For: DIVERTER VALVE

Serial No.: 10/595,281 Examiner: John C. Fox

REQUEST FOR RECONSIDERATION OF PATENT TERM ADJUSTMENT UNDER 35 U.S.C. § 154 AND 37 C.F.R. § 1.705(b)

Fig. 11

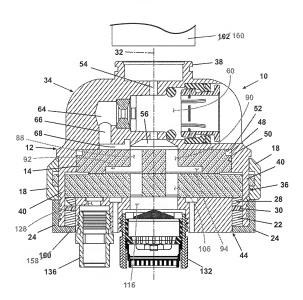
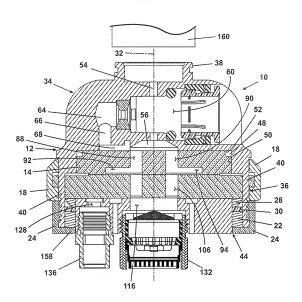
On page 6, line 28, it appears that it should read "mount 20 need not". On page 9, line 1 "an adapter 160" is mentioned but Figures 10,11, 18, 21 show an adapter 162. This adapter 162 also conflicts with seal 162 of Figure 19. On page 11, first full paragraph, both "sealing rings 162, 164, and 166" and "grooves 162, 164, and 166" are mentioned. Notch 174 is not labeled in Figure 19. In Figure 4, "86" labels both 86 and 84.

The informalities in the drawings and specification identified by the Examiner are noted with appreciation. Appropriate amendments to the specification and drawings have been made to clarify the issues raised by the Examiner.

Fig. 13

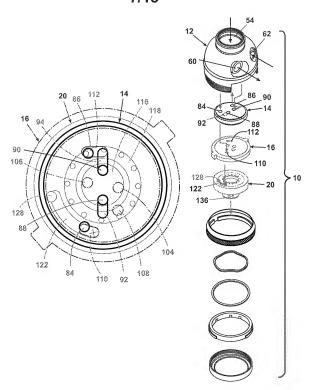
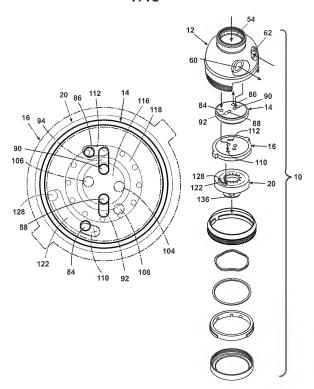
While there is no specific requirement as to how much of the drawings need be labeled, additional labeling would help to understand the invention. Figures 13, 14, 16 have been mentioned. "108" in Figure 5 and "112" in Figure 6 would be helpful. In Figure 11, elements 60, 88, 90, 92, 94, 104, 106, 116, 118, 120, 122, and 128, all of which are important to an understanding of the invention, are visible but unlabeled.
